ADDENDUM NO. 1

August 7, 2026

Parking Lot Expansion

Upper Valley Career Center
8811 Career Drive
Piqua, Ohio 45356

C-4.1

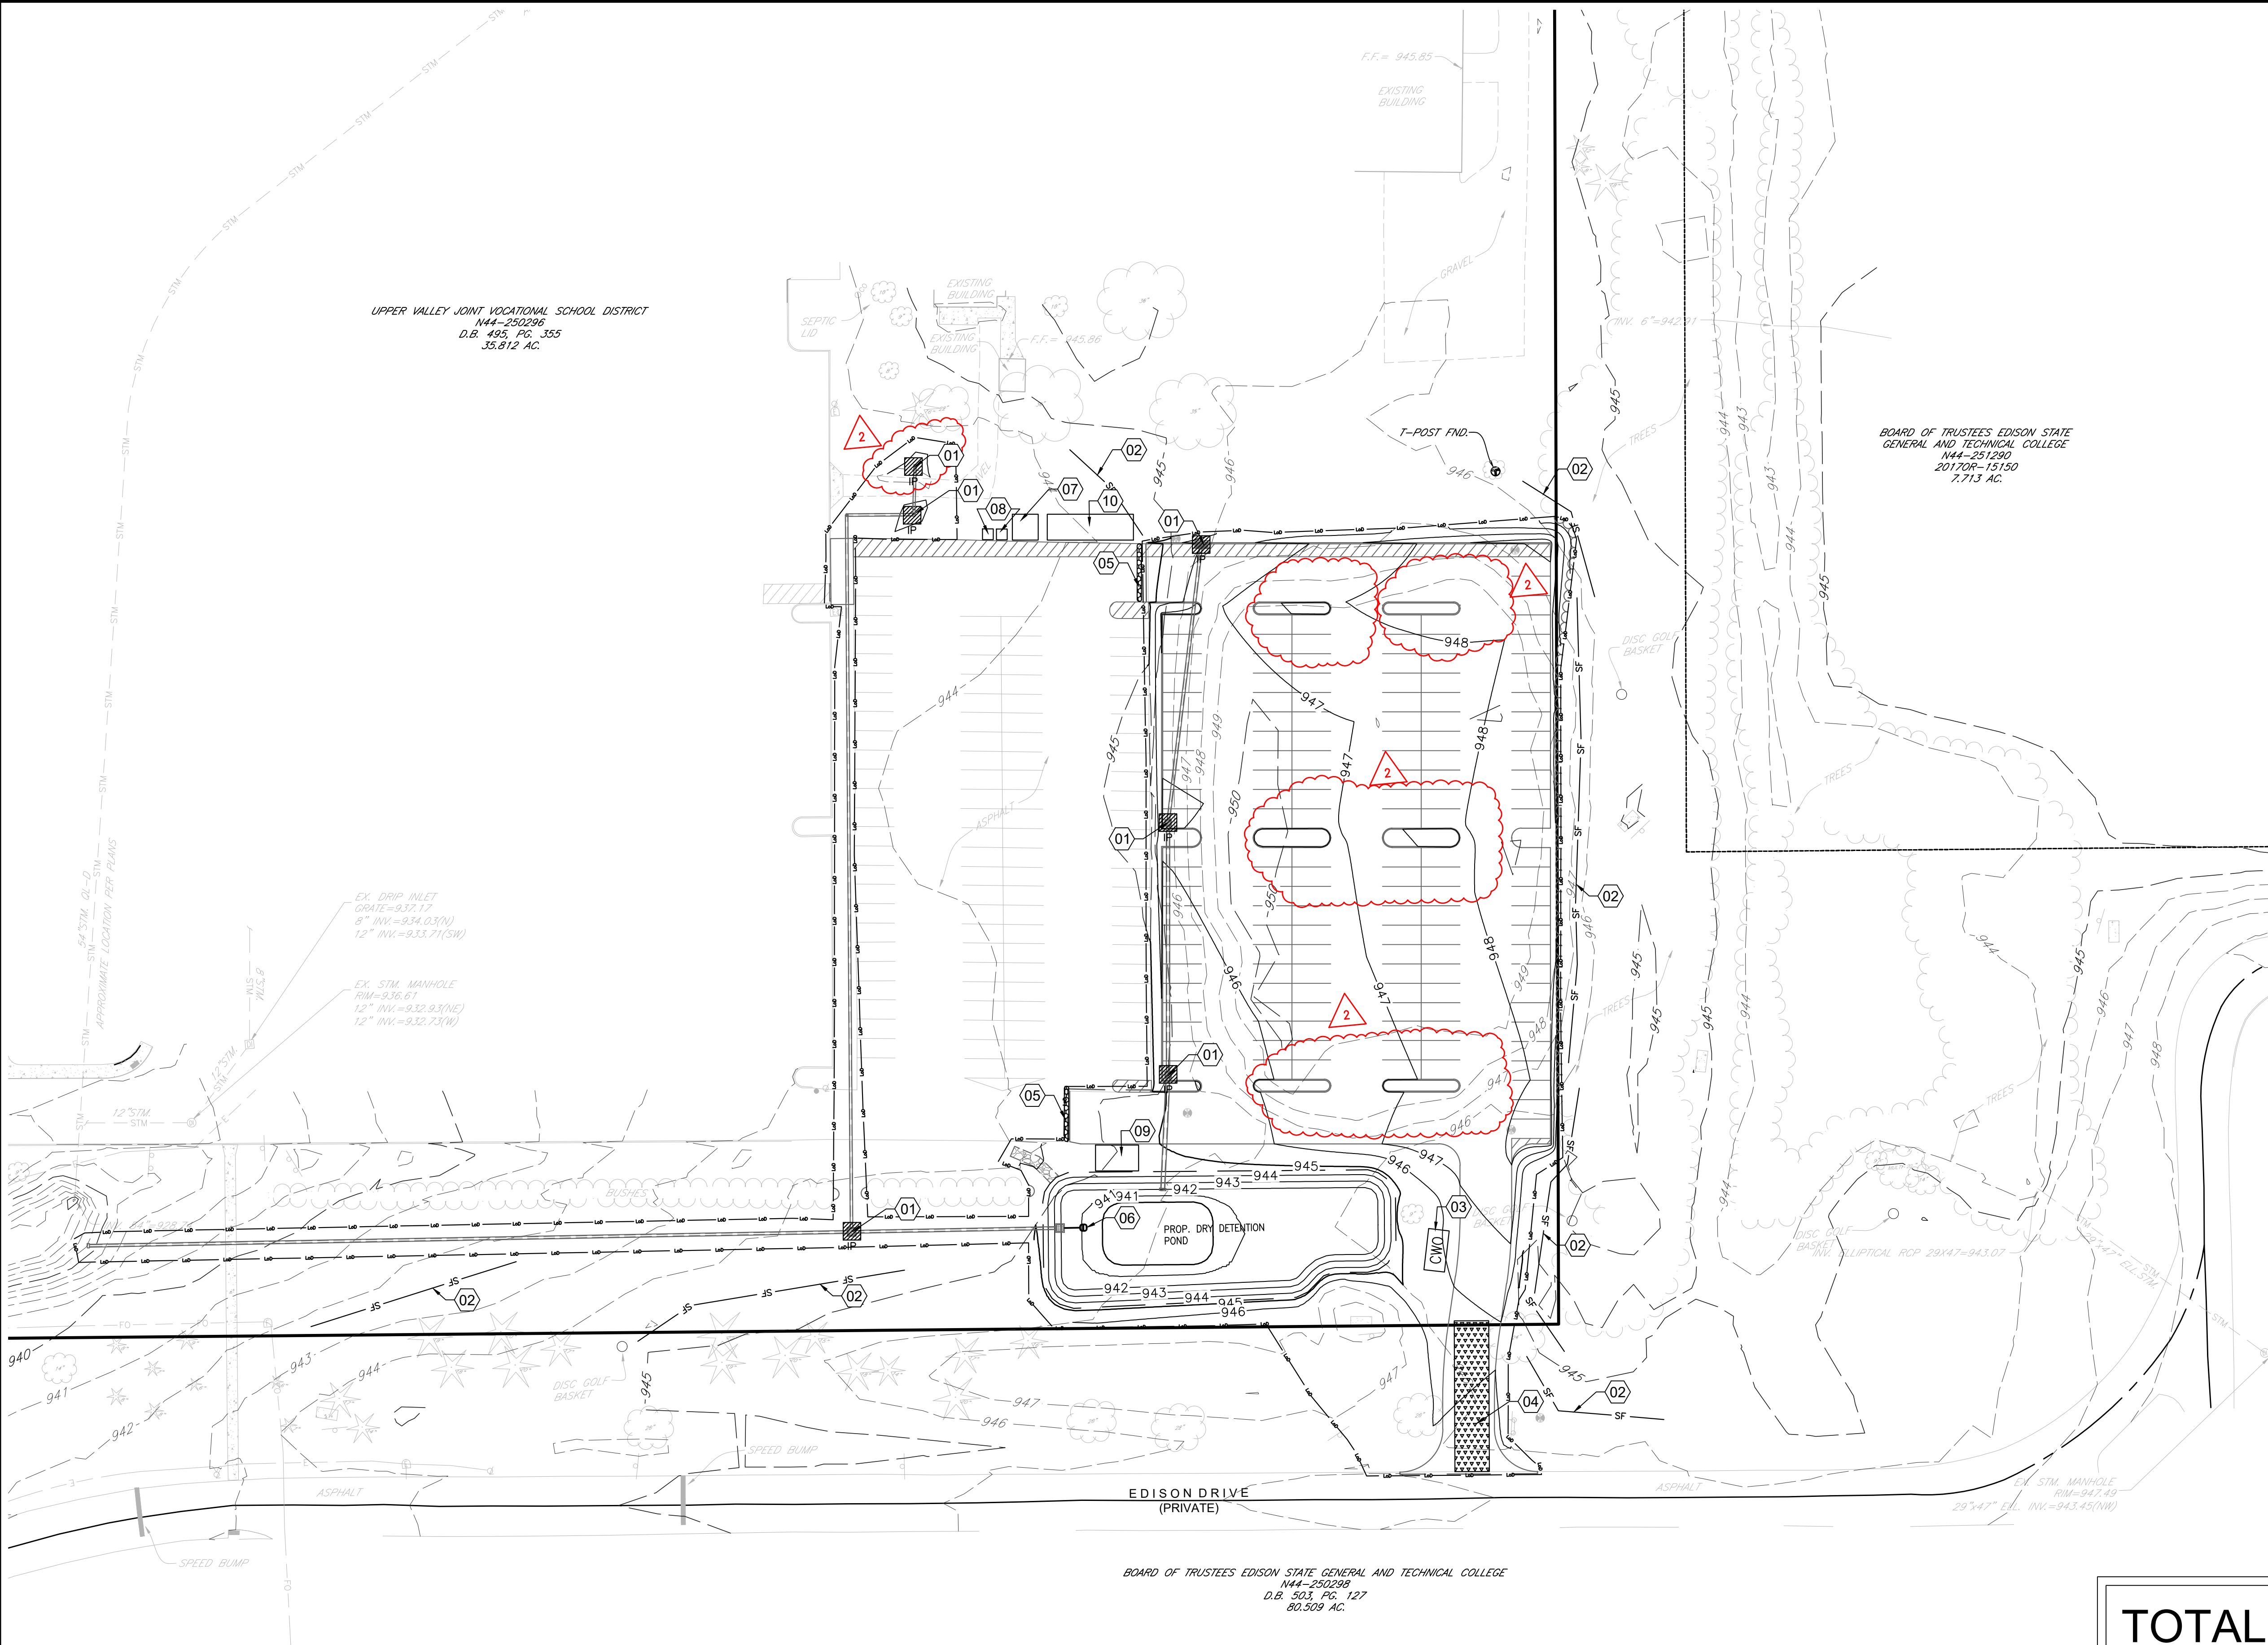
- 3.6 Sheet C-4.1 – Added new yard drain and cleanout to storm profile "101A to 101D" and revised callouts. Revised profile callouts to read "RCP" from structures 200 to 203.

Sheet No.:
C-6.7

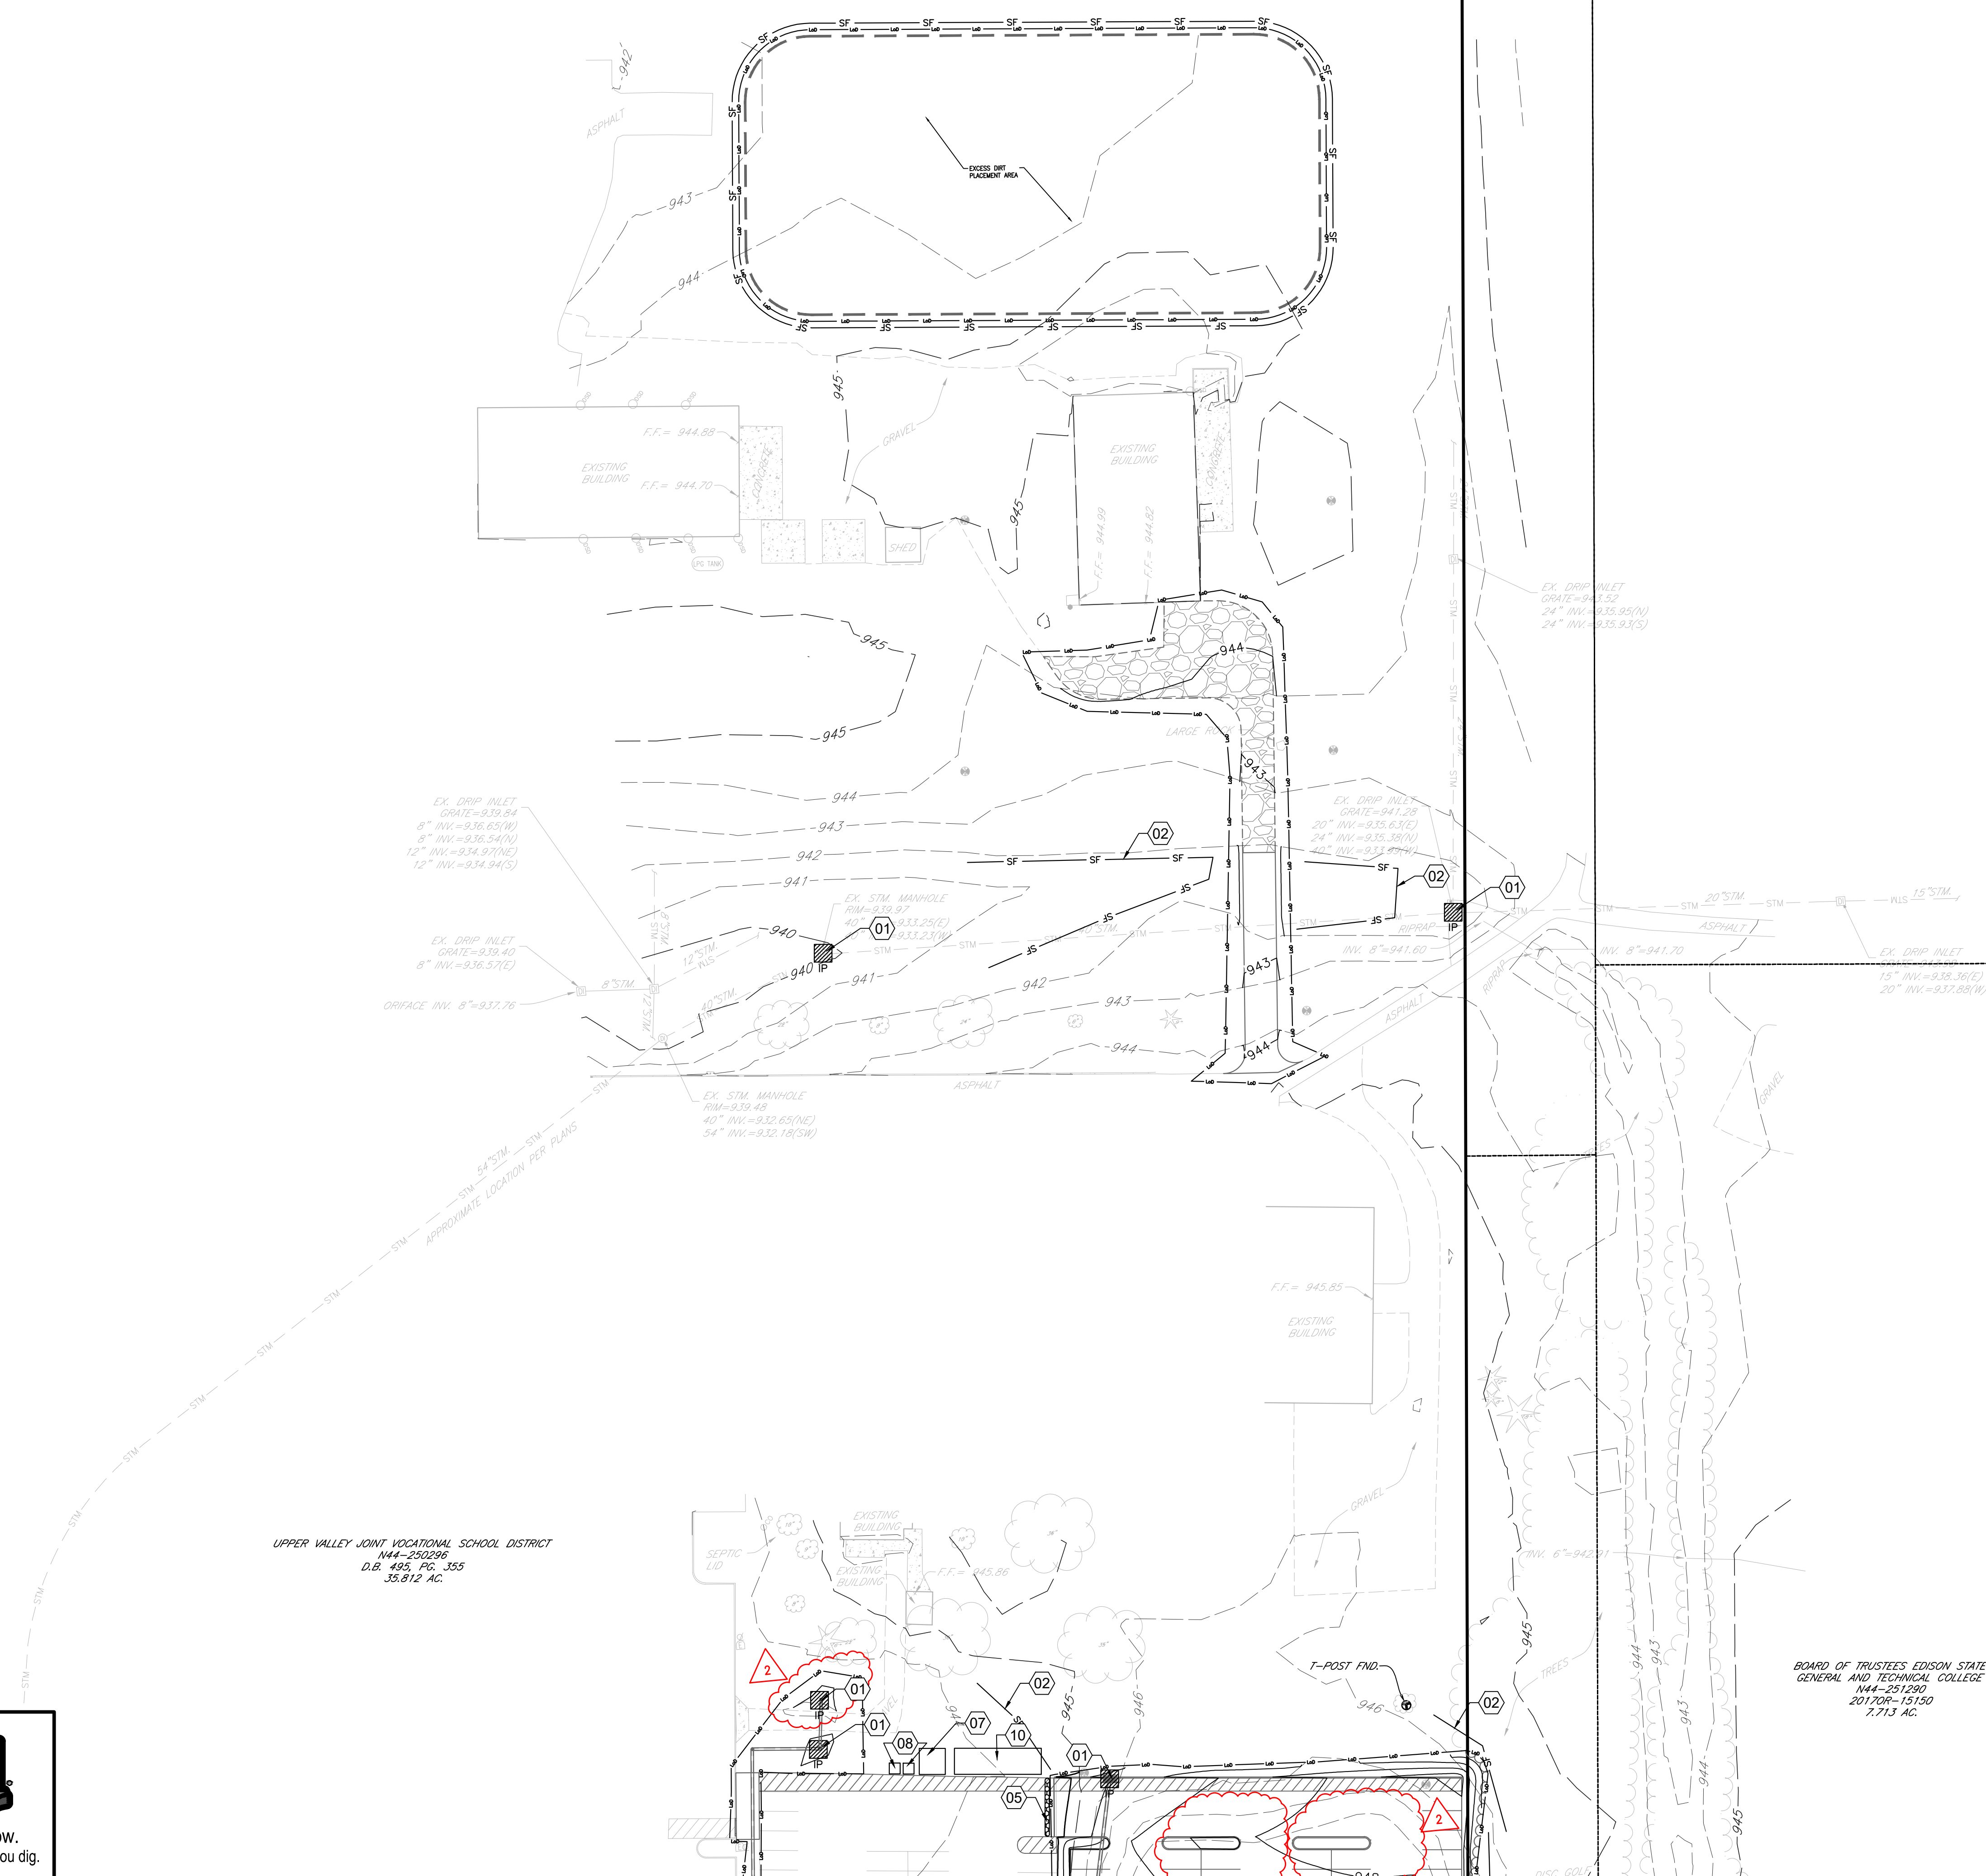
- 3.7 Sheet C-6.7 – Show new curbs islands in parking lot. Added additional inlet protection on new yard inlet.
- 3.8 Sheet C-6.8 – Overlapped area on this sheet shows items described on sheet C-6.7.

Design: NDT	Proj: 26143
Draw: NDT	Dwg:
Check: SRF	Tab:
Scale: SEE SHEET	
Date: 07.17.2026	
Sheet: PROPOSED DRAINAGE MAP	
Sheet No.: C-7.1

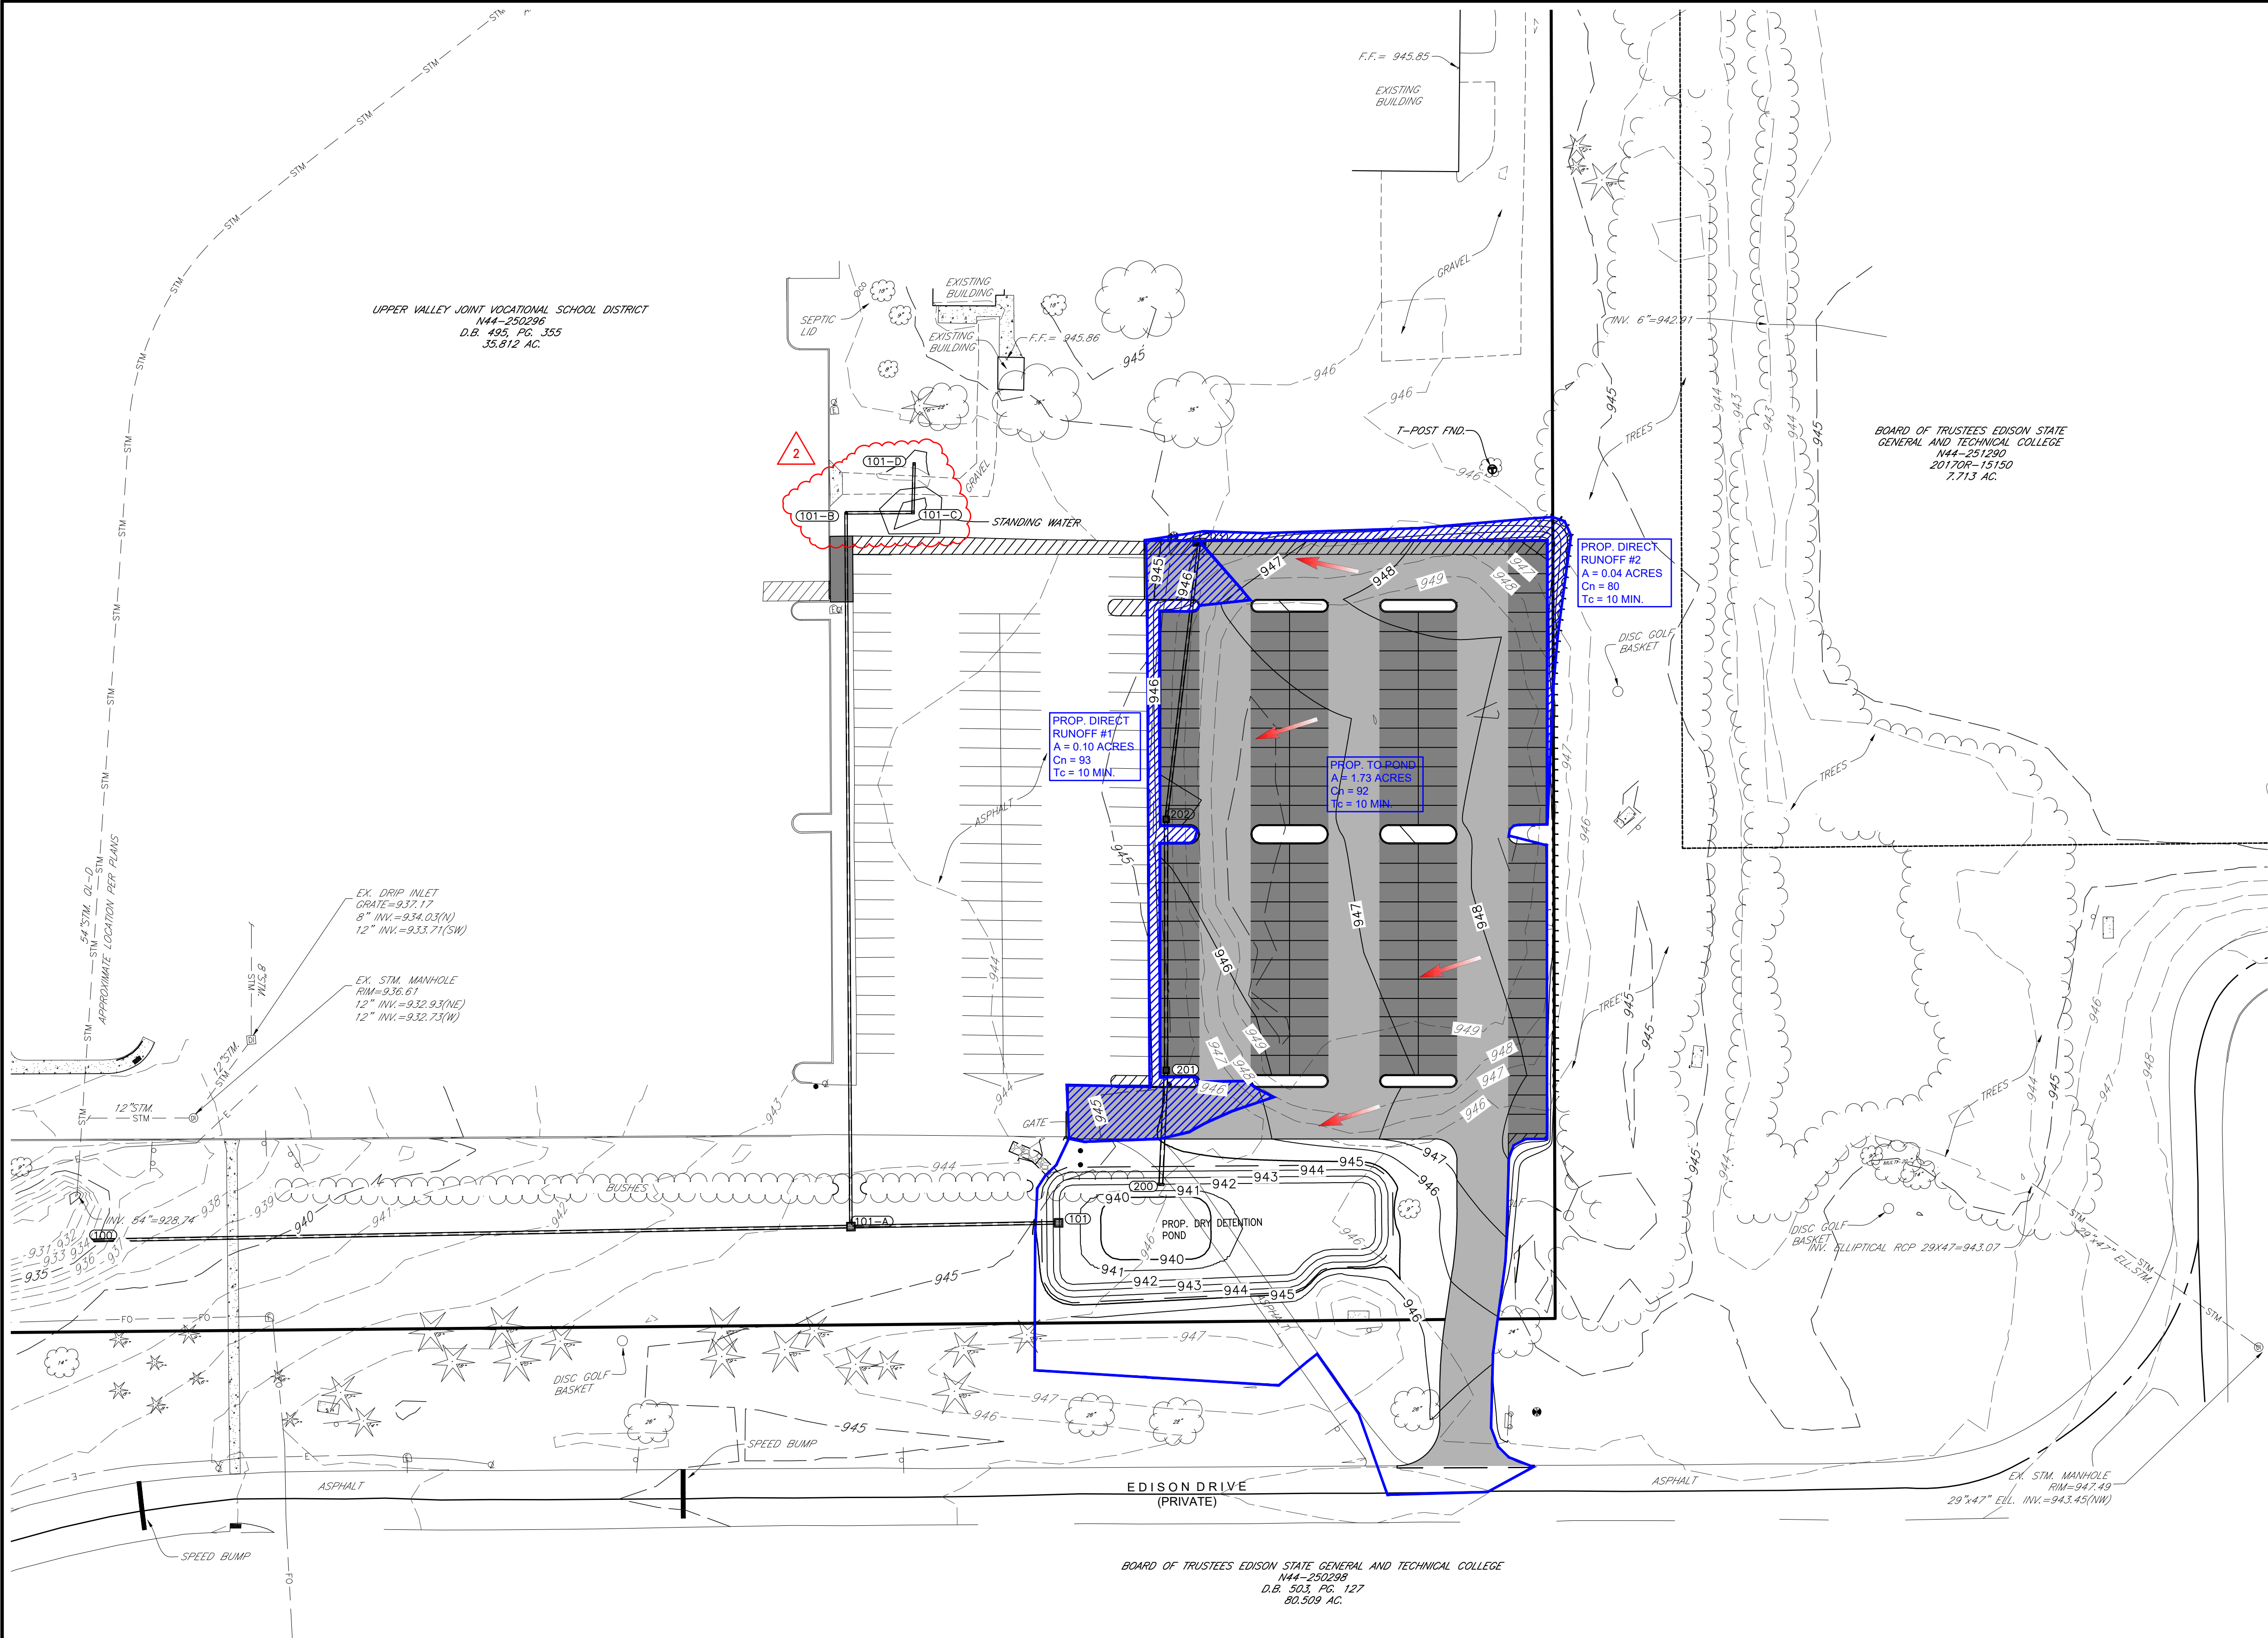
- 3.9 Sheet C-7.1 – Show additional yard drain and cleanout on drainage map.
- 3.10 Sheet C-7.3 – Added additional structures to storm sewer calculations.
